CITY OF OLYMPIA
MULTI-FAMILY RESIDENTIAL
Chapter 18.170

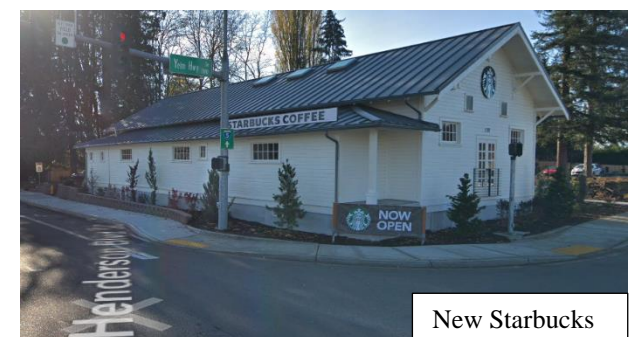
Staff Analysis: The project is located at the intersection of Henderson Boulevard and Yelm Highway, a prominent intersection at the edge of the City limits. Henderson Boulevard is within the Tumwater City

Yelm Highway Frontage: The project is similar in nature and size to the senior housing development directly across Yelm Highway. The adjacent Silver Leaf senior housing project places a strong emphasis on the pedestrian environment by locating buildings at the street edge and by providing a variety of architectural elements along the façade. The subject project proposal includes an approximate 10' building setback on this frontage, which is similar to that of Silver Leaf, but in contrast, the ground floor is occupied by a 10' tall brick wall associated with the partially underground parking garage. While the landscaping will probably screen the wall and parking garage, the pedestrian oriented nature of the adjacent development has not been provided. The level of façade articulation / modulation, building detailing, roof form modulation, etc. of the adjacent development should be more closely emulated.

Henderson Boulevard Frontage: The existing development along this frontage includes the recently renovated grange building which is now a coffee shop. This building is placed at the street corner and incorporates the agricultural and historic elements of the past. It is highly oriented towards the pedestrian environment. The remainder of development on the frontage is not visible from the site, but is predominately single family in nature. The project proposal along this frontage is primarily occupied by landscaping and a community garden. The building is significantly setback from the street, does not provide pedestrian connections to the street, and does not appear to take queues from the adjacent development.

Staff encourage the applicant to more clearly articulate how the existing development pattern has been reflected in the design of this building. Plans provided appear to be nearly identical to those submitted to the City of Puyallup, where a similar project is currently under review. Rather than replicating the same design in numerous communities, modify the design to more closely align to elements of the existing development pattern of this location.

- Revise plans to reflect the architectural character of the neighborhood through replication of roof forms, window patterns, building materials etc.
- With the detail design analysis, address how the project reflects / takes cues from the character of the existing development pattern within 300' of the site.
